Access Compliance Report Public Rights-of-Way (Curb Ramps)

Main Street: HICKORY_BRANCH_RD **Cross Street: HICKORY BRANCH RD** Location: SE ADA ID: RPAT211008142202 Ramp Type: Type 4 - Parallel **Initial Pass/Fail: Pass Overall Compliance: No Severity Score:**

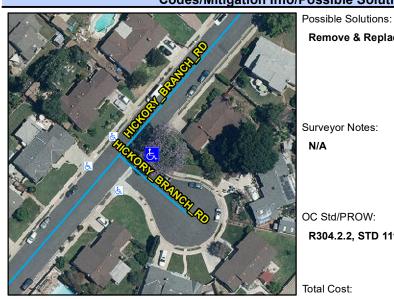
Remove & Replace Curb Slope.

R304.2.2, STD 1115
